**FILE**  
15-163947

**RE: OPPOSITION TO SCALE OF DEVELOPMENT AT 1174 GRAND AVENUE**

## Re: 1174 Grand Avenue Development Proposal

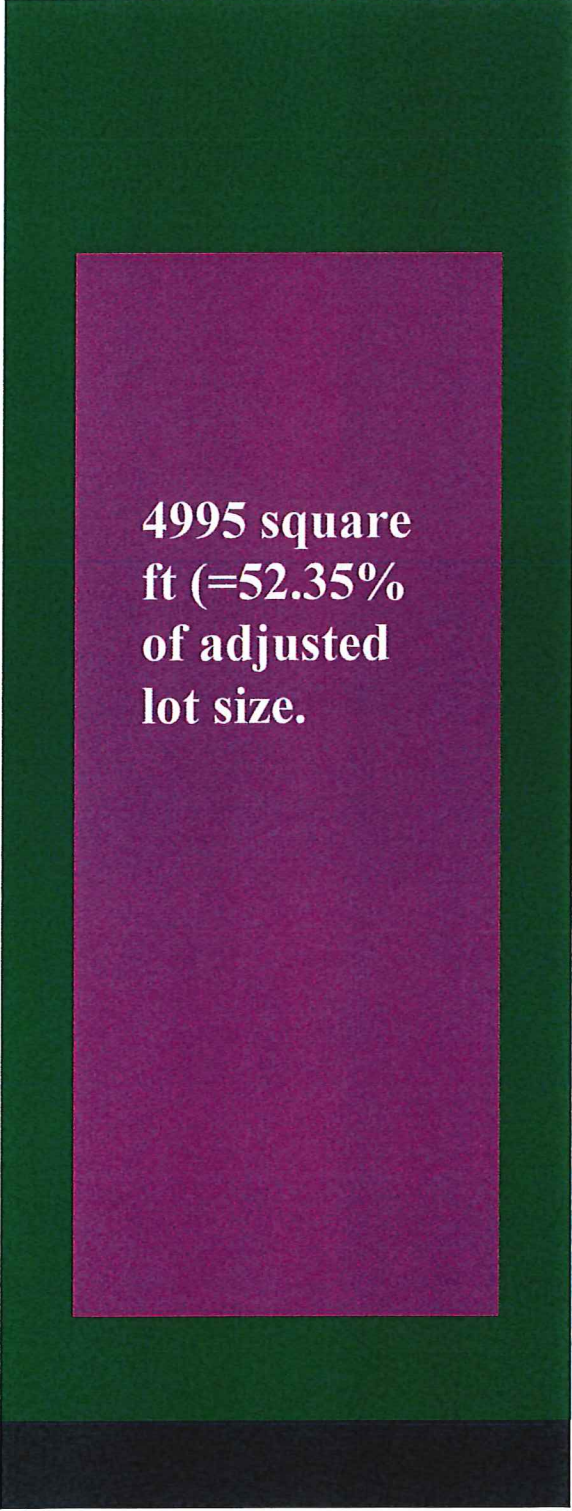
Lot size = approx. 9,000 sq ft/ 9540 sq ft  
w/ alley allowance

3,339 sq ft  
(=35% of  
adjusted lot  
size of 9540  
sq ft.)

4995 square  
ft (=52.35%  
of adjusted  
lot size.
